Access Compliance Report

Public Rights-of-Way

Intersection ID: 10022963	Main Street: CEDAR_WALK_LN	Cross Street: N/A	Location: S
ADA ID: B41F3EDBF09A	Ramp Type: BlendTrans1	Initial Pass/Fail: Fail	Overall Compliance: No
		Severity Score: 60

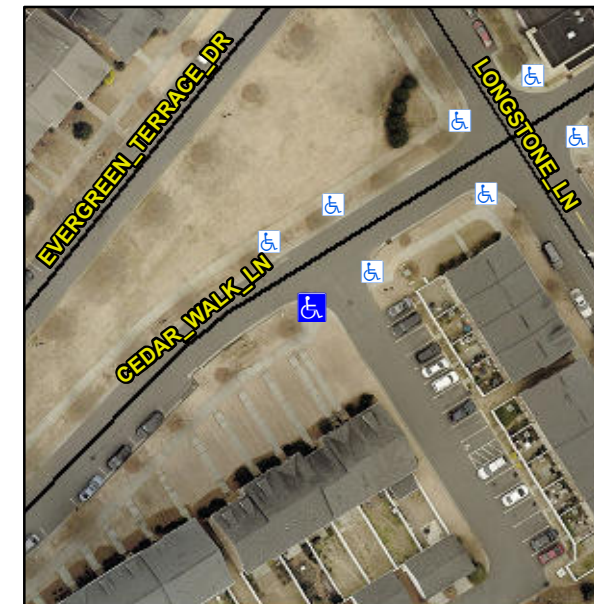
Not Found, R304.5.1, R304.5.3

Compliance	Description	Data	Compliance	Description	Data
N/A	Ramp Length (in)	163.5	Yes	BlendTrans Slope (%)	3.8
No	Ramp Width (in)	27.5	No	BlendTrans XSlope (%)	7.2
N/A	Flare Type LT	N/A	N/A	Flare Type RT	N/A
N/A	Flare Slope LT (%)	N/A	N/A	Flare Slope RT (%)	N/A
N/A	Flare Traversable LT?	N/A	N/A	Flare Traversable RT?	N/A
N/A	Landing Length (in)	N/A	N/A	DWS Provided?	N/A
N/A	Landing Width (in)	N/A	N/A	DWS Contrast?	N/A
N/A	Landing Slope (%)	N/A	N/A	DWS Length (in)	N/A
N/A	Landing X Slope (%)	N/A	N/A	DWS Full Width?	N/A
N/A	Landing Curb? (Y/N)	N/A	N/A	DWS Offset (in)	N/A
N/A	Shared Landing?	N/A			
N/A	Gutter Ponding?	N/A	N/A	Gutter Slope (%)	N/A
N/A	Gutter Lip Ht (in)	N/A	N/A	Gutter X Slope (%)	N/A
N/A	Painted X Walk1?	No	N/A	Painted X Walk2?	No
	X Walk 1 Direction	To NE		X Walk 2 Direction	To NW
	X Walk 1 Width (in)	N/A		X Walk 2 Width (in)	N/A
	X Walk 1 Slope (%)	0.9		X Walk 2 Slope (%)	1.4
	X Walk 1 X Slope (%)	2.6		X Walk 2 X Slope (%)	3.0

N/A	Ramp inside XWalk1?	N/A	N/A	Ramp inside XWalk2?	N/A
	Road Slope (%)	4.7		Clear Space?	N/A
	Road X Slope (%)	0.4	N/A	Clear Space to XWalk (in)	N/A
N/A	Any Obstructions?	N/A	N/A	Storm Grate/Utility Hazard?	N/A
	Obstruction Type			Storm Grate/Utility Type	
		N/A			N/A
			Yes	Surface Condition? (G/P)	Good
			No	Curb Slope (%)	19.2

Remove & Replace Curb Ramp With Two New Directional Ramps or Equivalent.
